NRC DOCKETS 50-321, 50-366
OPERATING LICENSES DPR-57, NPF-5
EDWIN I. HATCH NUCLEAR PLANT UNITS 1, 2
NRC I&E BULLETIN 80-11

NRC I&E BULLETIN 80-11, "MASONRY WALL DESIGN"

RESPONSE TO NRC REQUEST FOR
ADDITIONAL INFORMATION

EDWIN I. HATCH NUCLEAR PLANT

Project	HATCH-UNIT NO. 1 & 2	Prepared By	TINA C. SALSER	Date	12-1-80
Subject/Title	WALL MODIFICATION	Reviewed By	K. L. WHITEHEAD	Date	12-8-80
C-130-14A & 14B (PSOC-80-004)		Calculation Number		Sheet	9 of 11

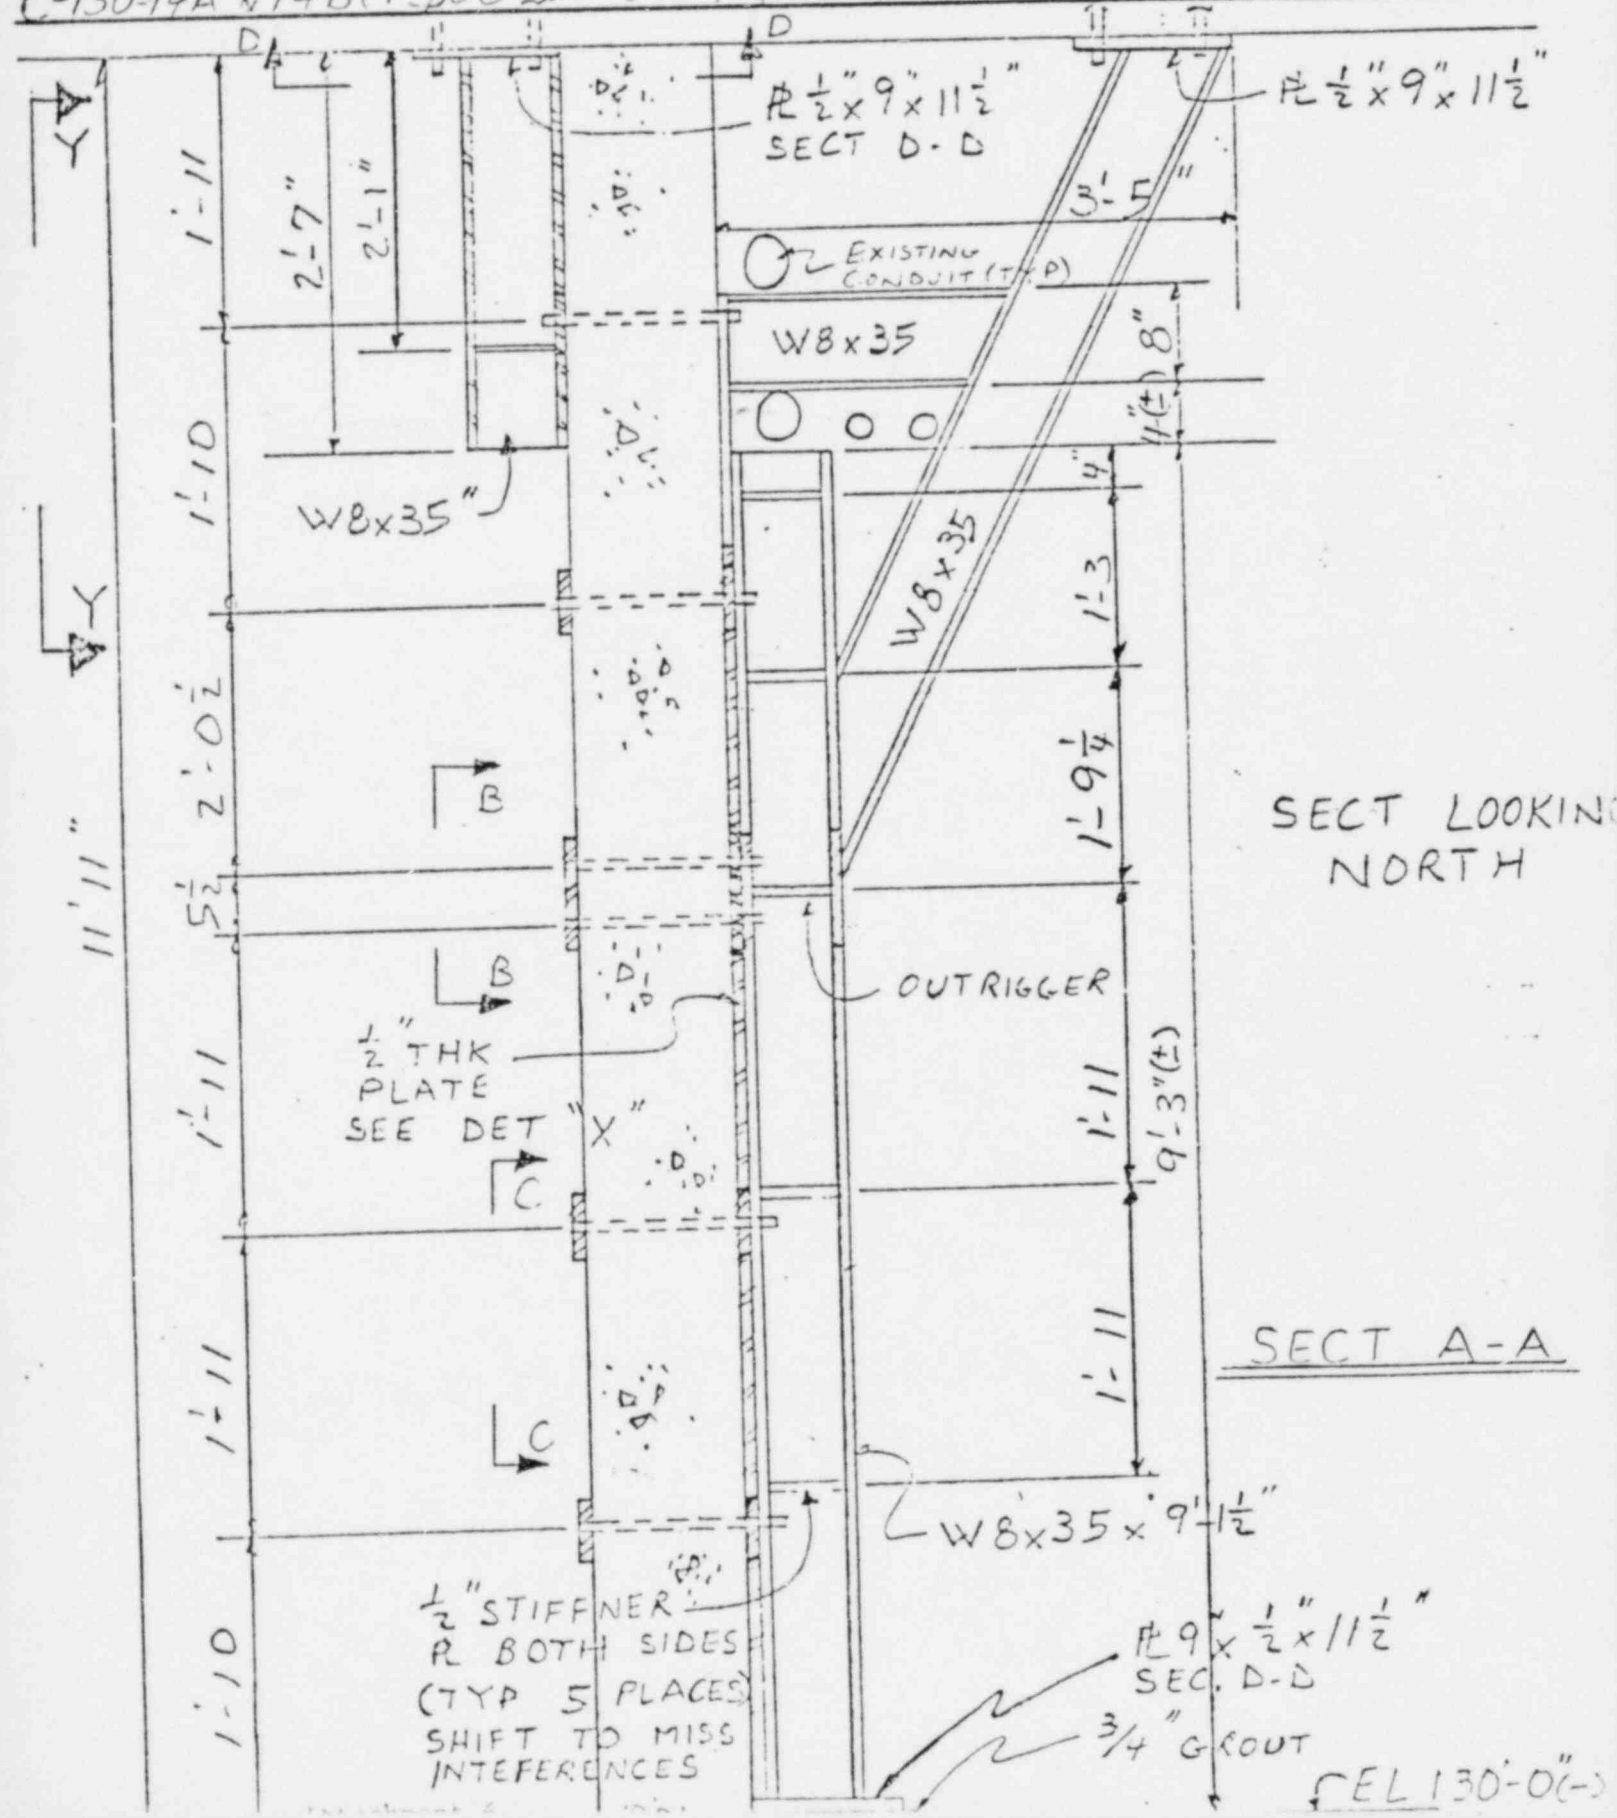
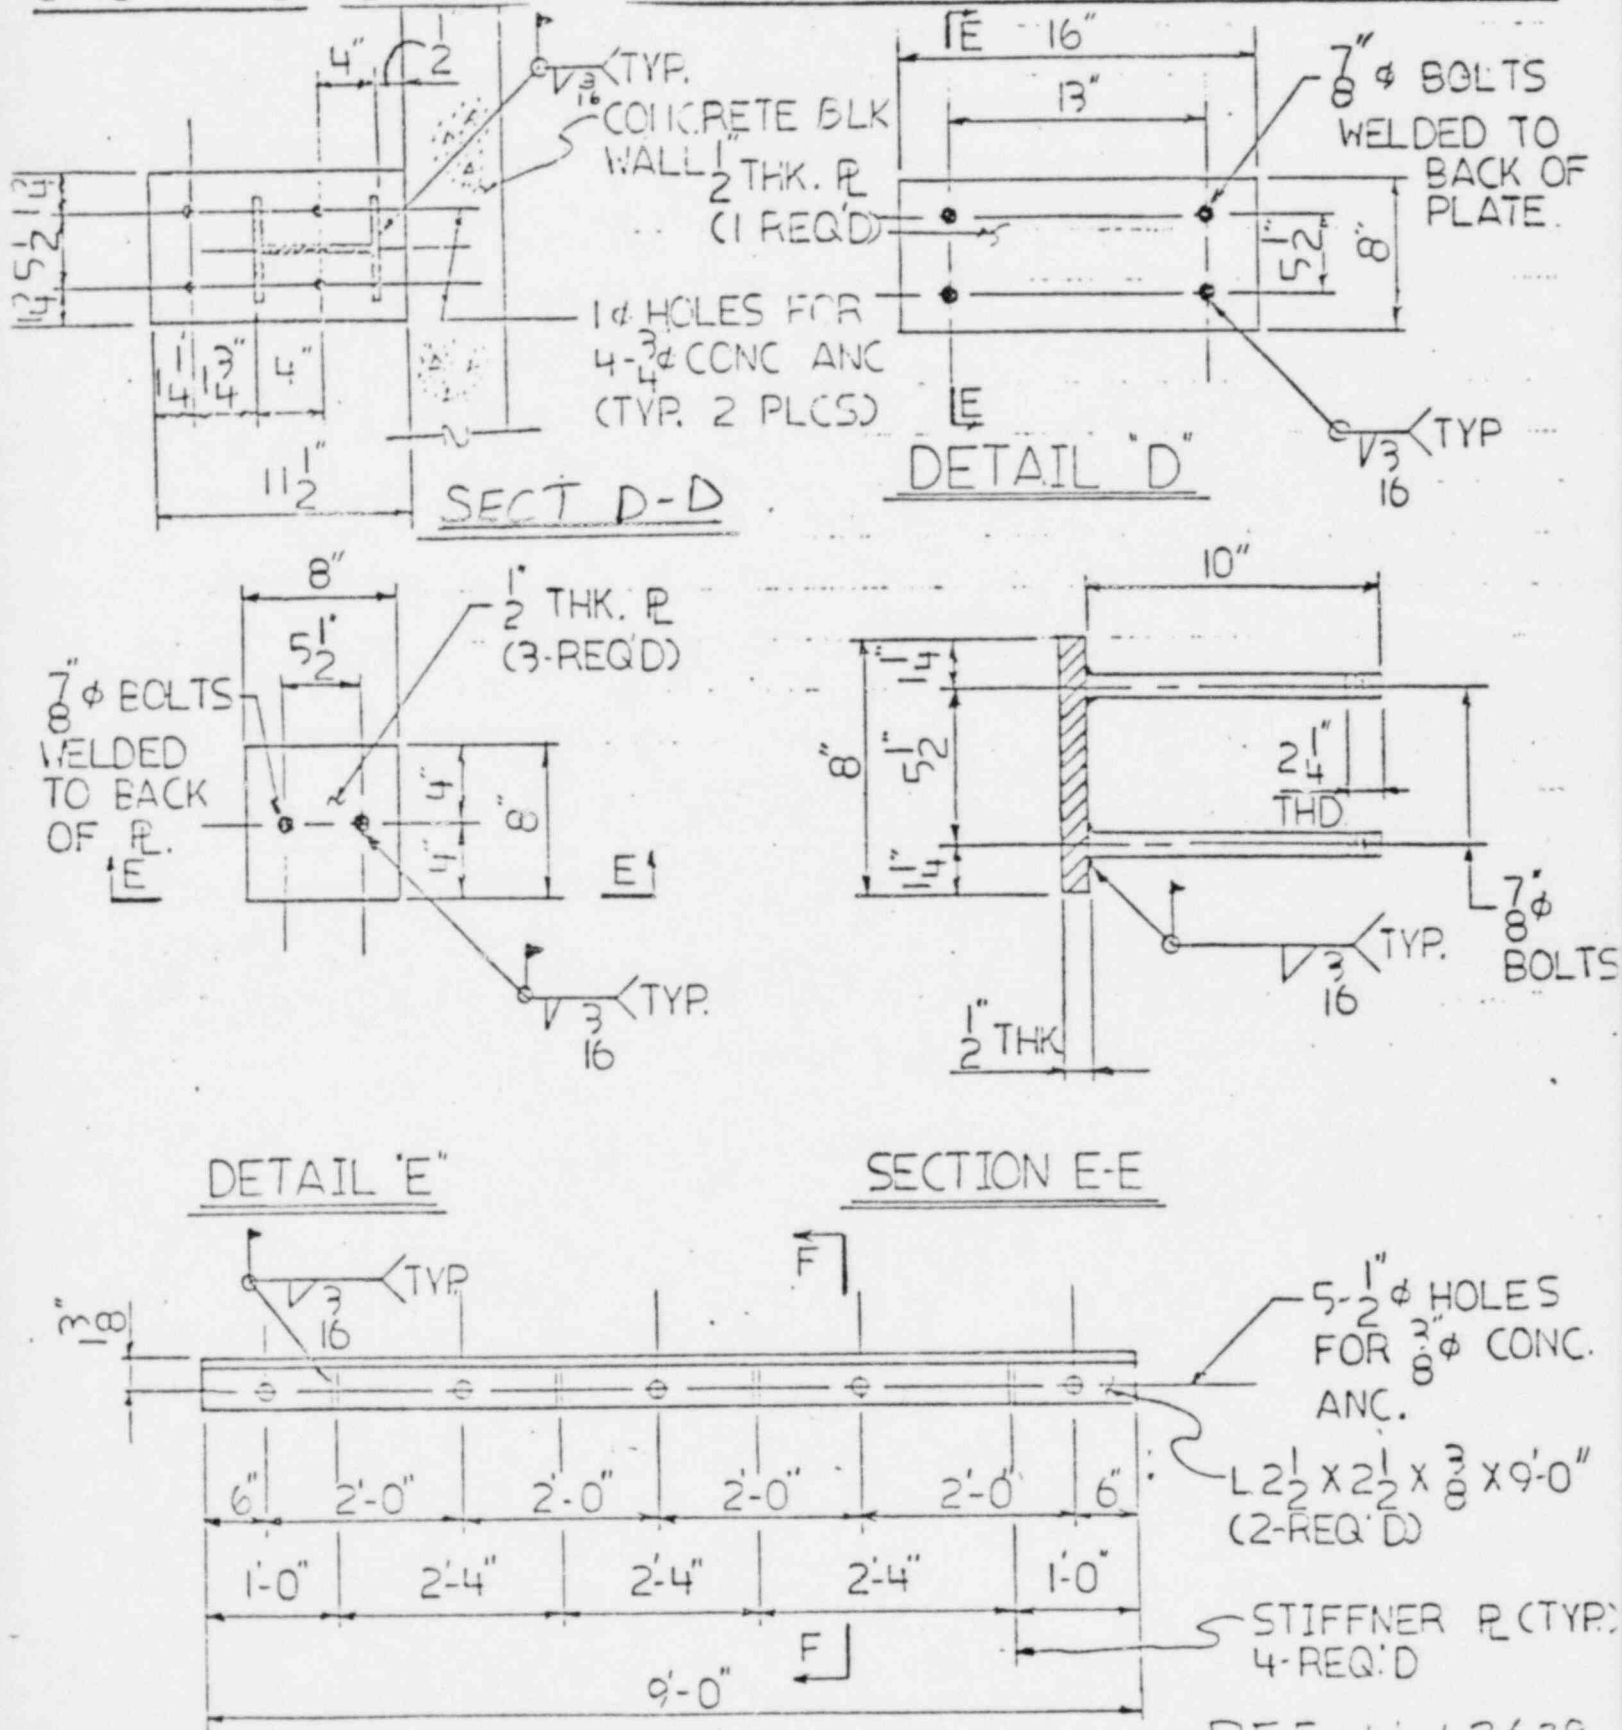
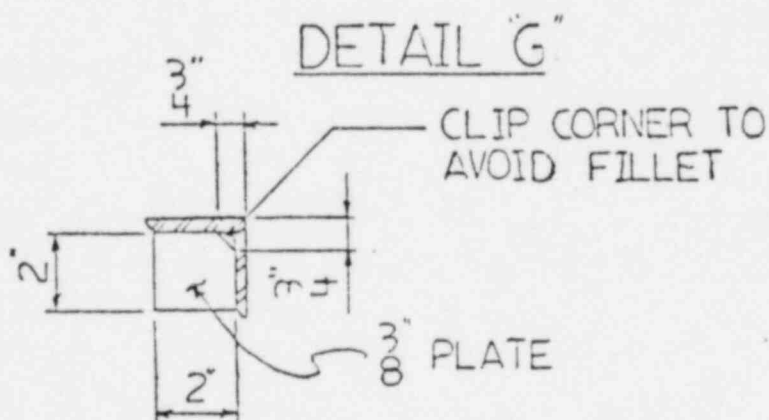
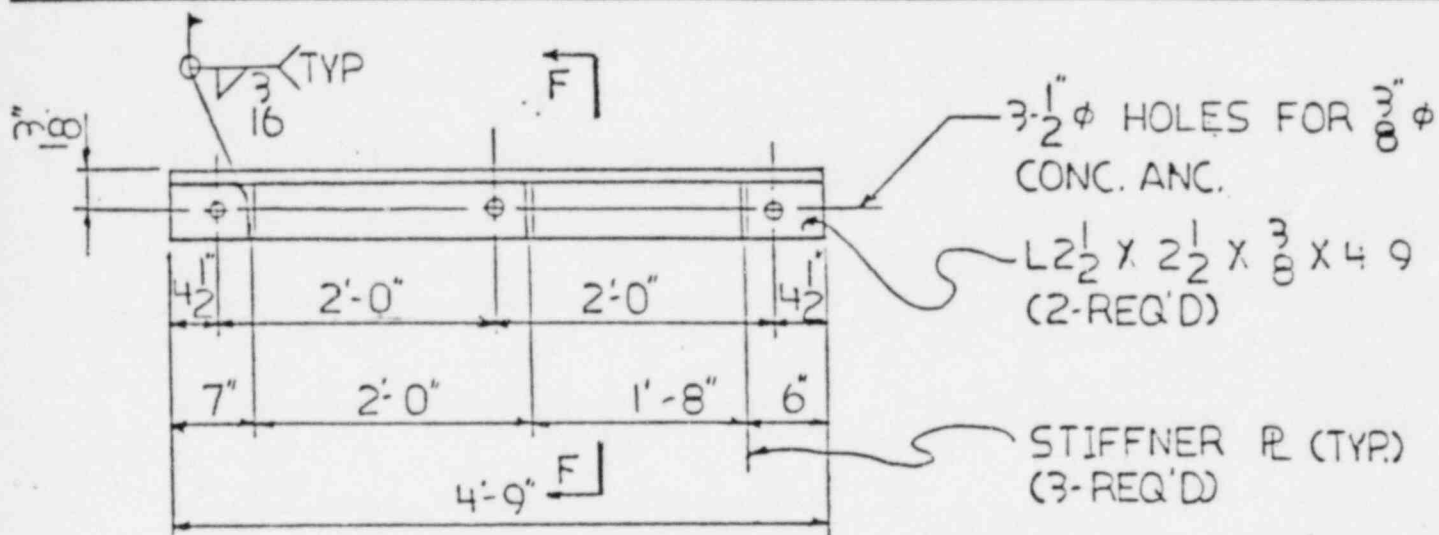
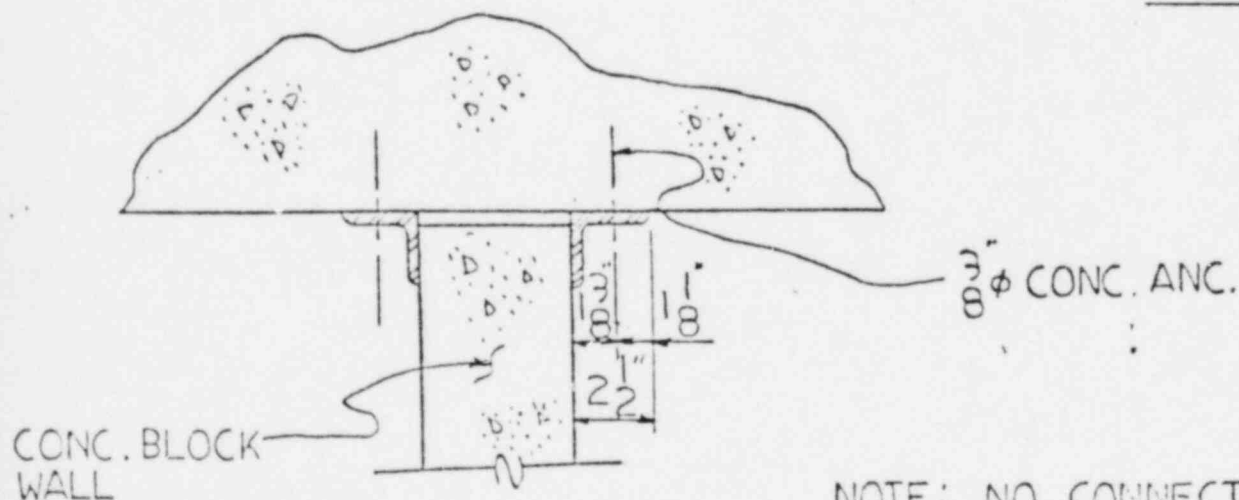
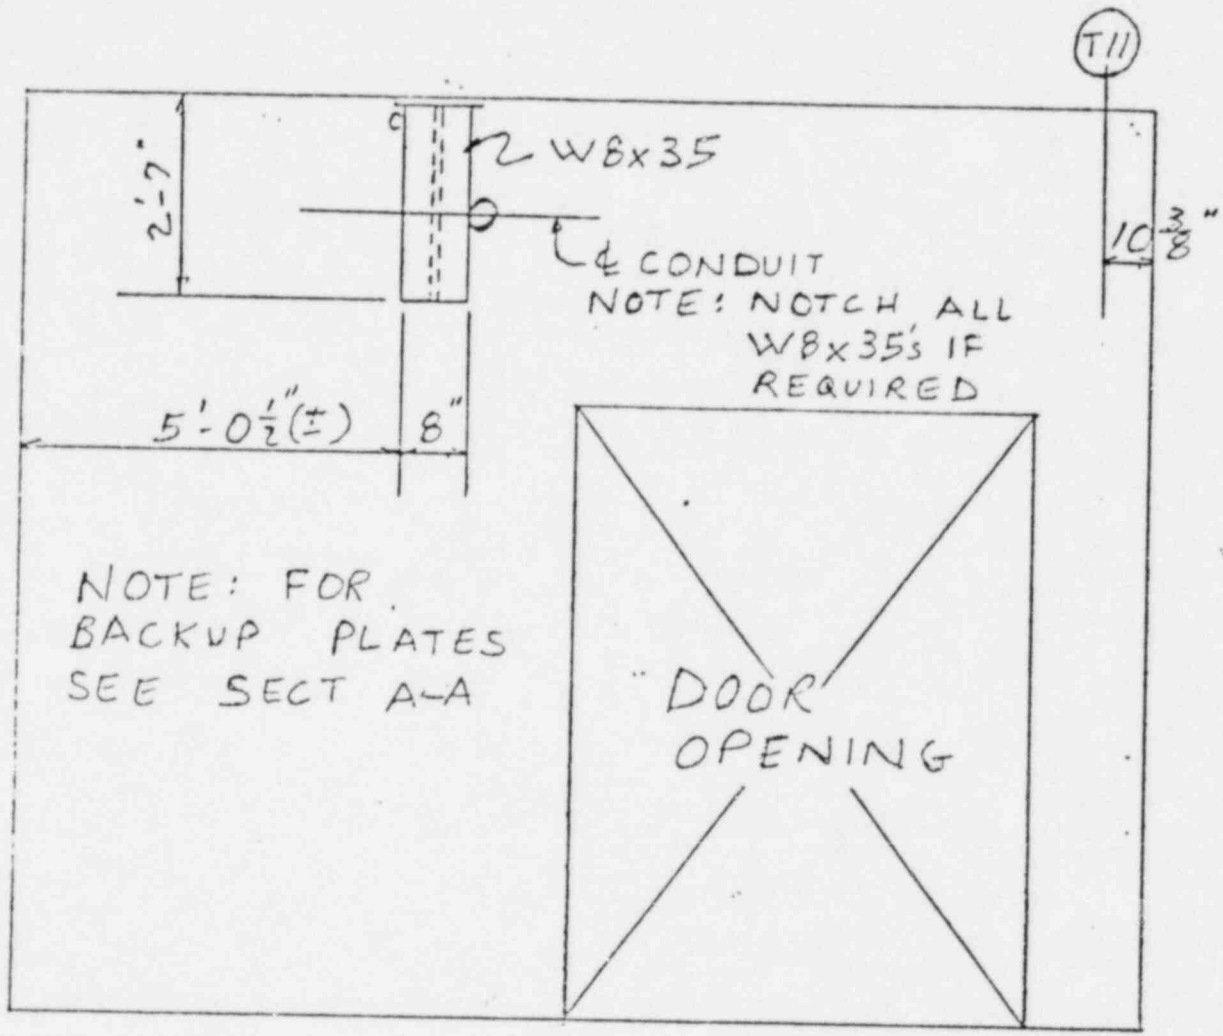
Provide details of modifications for all walls that do not satisfy the design allowables. Technical discussion should be provided detailing how these modifications will correct this deficiency. Also, provide the modification schedule.

A number of walls were modeled for STRUDL-DYNAL and had a finite element analysis run of the as-built condition, taking into account all loads and load combinations. A total of ten (10) walls were identified where calculated stresses exceeded allowable stresses. The results of the analysis showed that the effective horizontal span length of the wall should be reduced. Therefore, a point somewhere within the middle one-third of the span of the wall was chosen considering obstructions and installation problems, and one or more structural steel columns were erected to provide additional support for the wall. The column(s) were designed to withstand the applied loads and were used to brace the wall as shown in the attached sketches. The wall was then re-modeled for STRUDL-DYNAL, including the steel column, and a finite element analysis was performed again for all postulated loads and load combinations. Resulting moments and shears for the masonry wall and support column were checked against allowables. In addition, bolts, plates, and welds for the support having an angle brace were checked for worst-case loads. Wall number C130-14A&B had an angle brace attached to the ceiling on each side of the wall to provide lateral shear support and reduce a local overstress condition to within allowables. Following the analysis using the modified models, each wall was determined to satisfy all stress allowables.

Detailed sketches of the modification for each wall are shown in attachments 1 through 8. The field modifications for each wall are complete except for wall C164-4A&B and wall C130-39A&B. Both of these walls will be removed in the near future to allow for relocation of the shift supervisors office and modifications in the health physics area. Therefore, no modifications have been scheduled for these walls.
